**DELAWARE RIVER JOINT TOLL BRIDGE COMMISSION
EXECUTIVE OFFICES
2492 RIVER ROAD
NEW HOPE, PENNSYLVANIA 18938-9519**

**CONTRACT NO. T-668A, CAPITAL PROJECT 0301A
THE SCUDDER FALLS BRIDGE REPLACEMENT PROJECT**

ADDENDUM NO. 4

RESPONSES TO CONTRACTOR INQUIRIES SUBMITTED TO THE
COMMISSION
FROM OCTOBER 8, 2016 THROUGH NOVEMBER 1, 2016
INQUIRIES BY POTENTIAL BIDDERS

TYPICAL SUBBASE TREATMENT

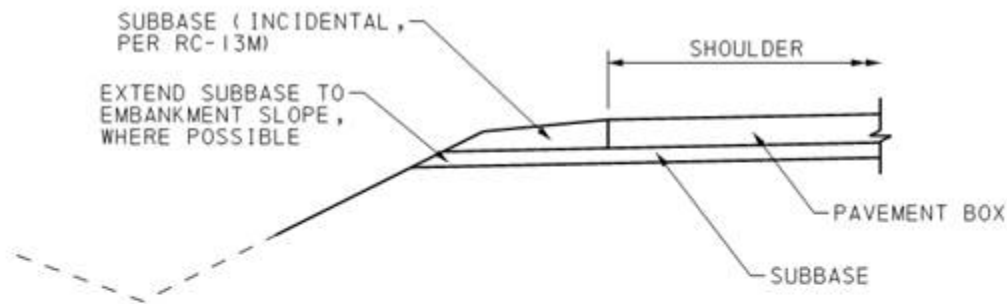
Inquiry 127: In addition, on the typical sections for the roadway in bid package A it appears there may be incidental subbase intended as roadway backup above the perceived subbase bleedout. This potential incidental subbase is not labeled as such and may be interpreted as embankment backup. Please clarify what is intended for the roadway backup see sheets 24, 25, 26, etc. of 280. If subbase is the intention can a subbase item be added and paid by the ton? If it is intended to be subbase and is to be incidental, could the typical sections be labeled as such?

***Response 127:** Where possible, the subbase should be extended to the embankment slope. Per PennDOT Standard Detail RC-13M, the subbase placed above the “bleedout” is incidental. The following detail will be added to Sheet 52 of 280 in Package A, Part 1, to clarify the treatment of the subbase:
